REMARKS/ARGUMENTS

Appl. No. 10/698,198
Amd. Dated January 20, 2005
Reply to Office Action of October 6, 2004

Fig. /
PRIOR ART

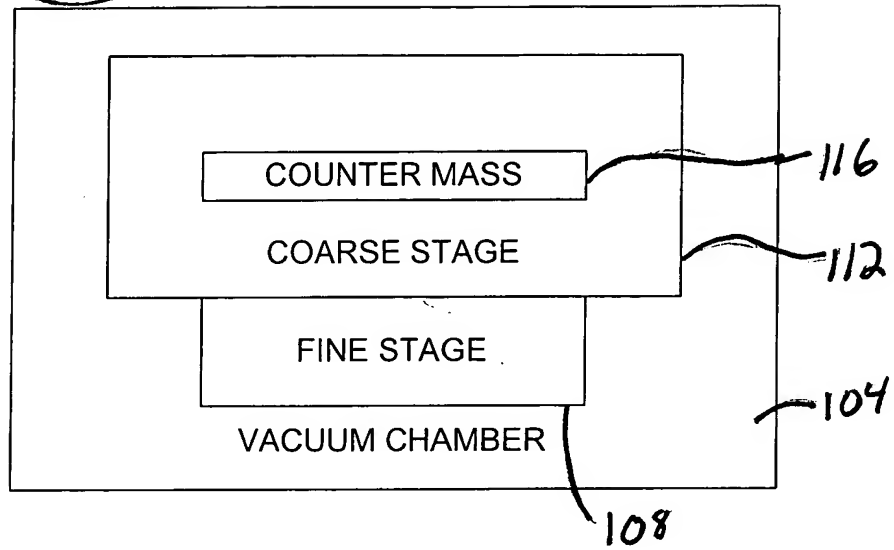
The drawings have been objected to by the Examiner. In response to the Examiner's objection to Figure 1, Figure 1 has been amended to include a --Prior Art-- legend. Drawings sheets which show the amendment made to Figure 1, as well as a replacement sheet for Figure 1, are being submitted herewith. As such, it is believed that the Examiner's objection to Figure 1 has been overcome.

The attached sheet of drawings includes changes to Fig. 1. This sheet, which includes Fig. 1, replaces the original sheet including Fig. 1.
